RE: Lot 10 Block 4 Unit 18, S.A.D. 228 Volcano Cliffs Subdivision 6611 Cuervo Pl. NW **Grading and Drainage Plan Engineers Stamp Date 12/13/2021** Pad Cert Date: 1/27/2022 (D10D003J10)

CANDELARIA HOMES (ADAN) - G & D PLAN

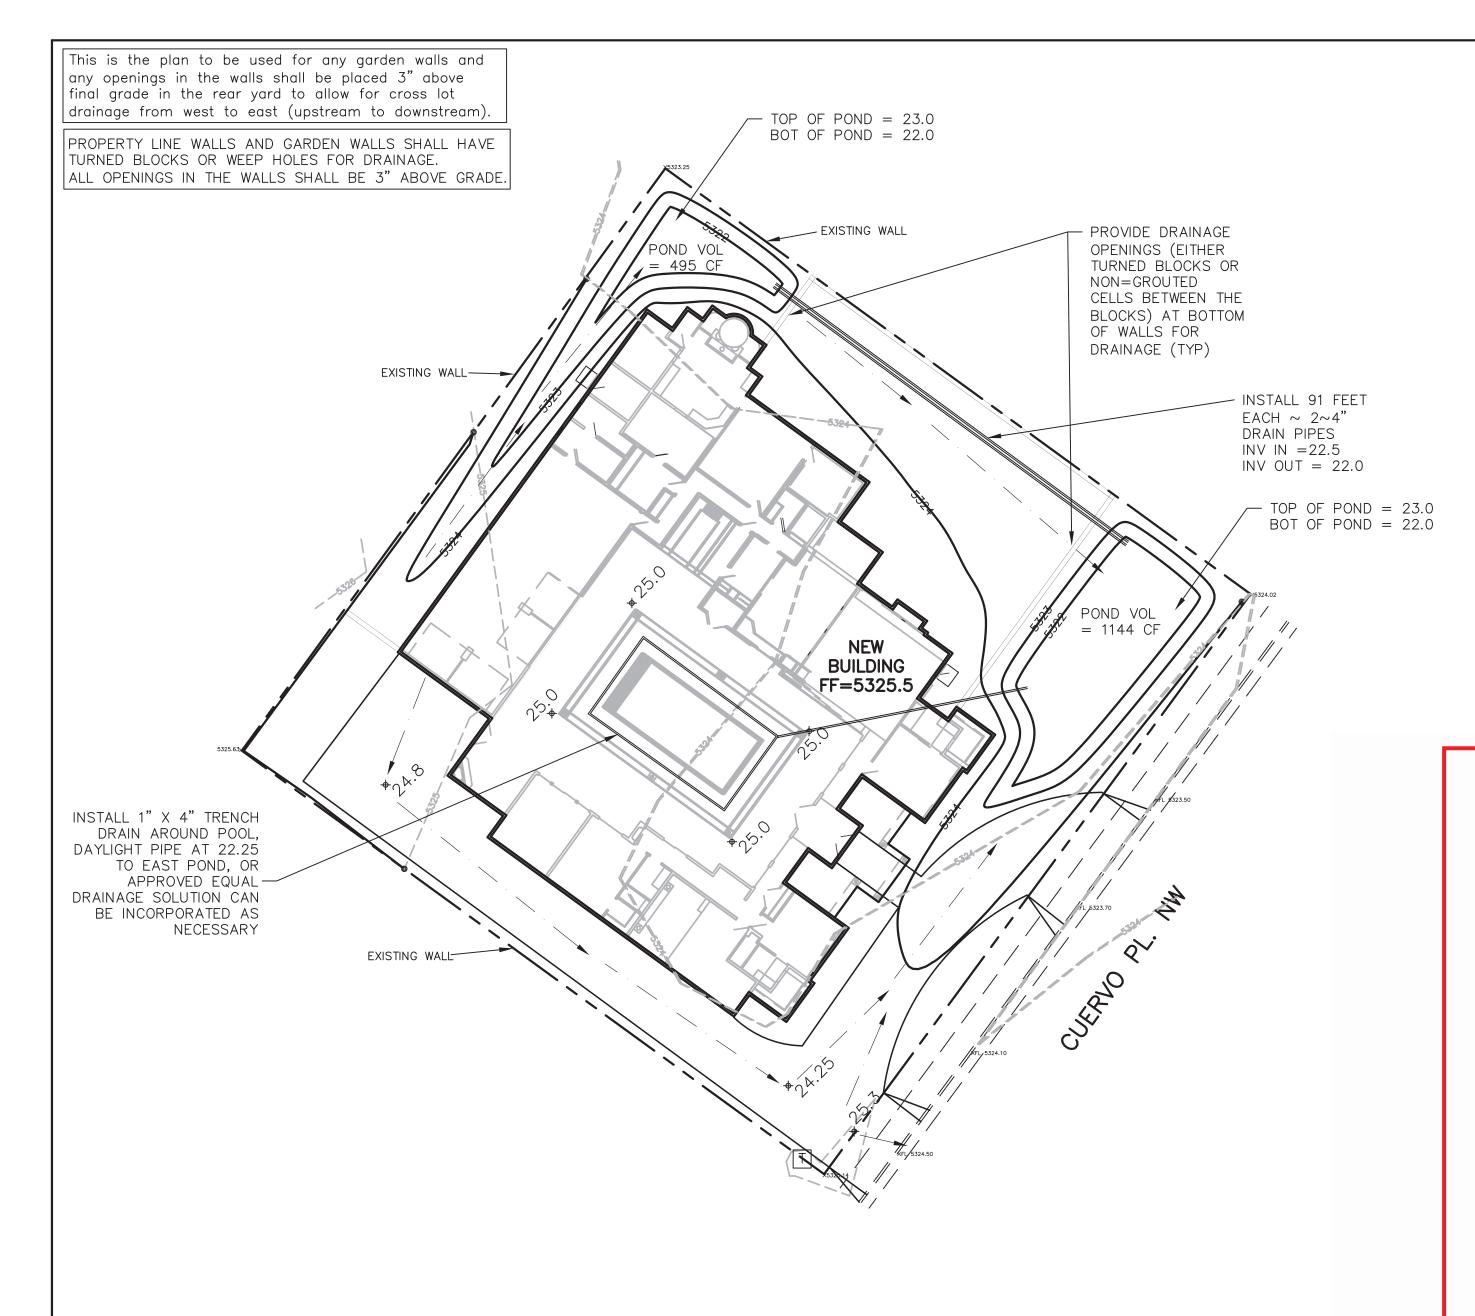
Based upon the information provided in your submittal received 3/2/2022, this plan is approved for Building Permit. Dirt is not allowed to climb the curb, use crusher fines or lumber for PO Box 1293 this purpose. Place this note on the plan.

Prior to Building permit approval a Pad Certification will be required, provided by the Engineer or a registered Land Surveyor.

Reiterate to the Owner/Contractor that a separate permit for a garden/retaining wall must be obtained, with the approved G&D plan.

Prior to Certificate of Occupancy release, Engineer Certification per the DPM checklist of this plan will be required.
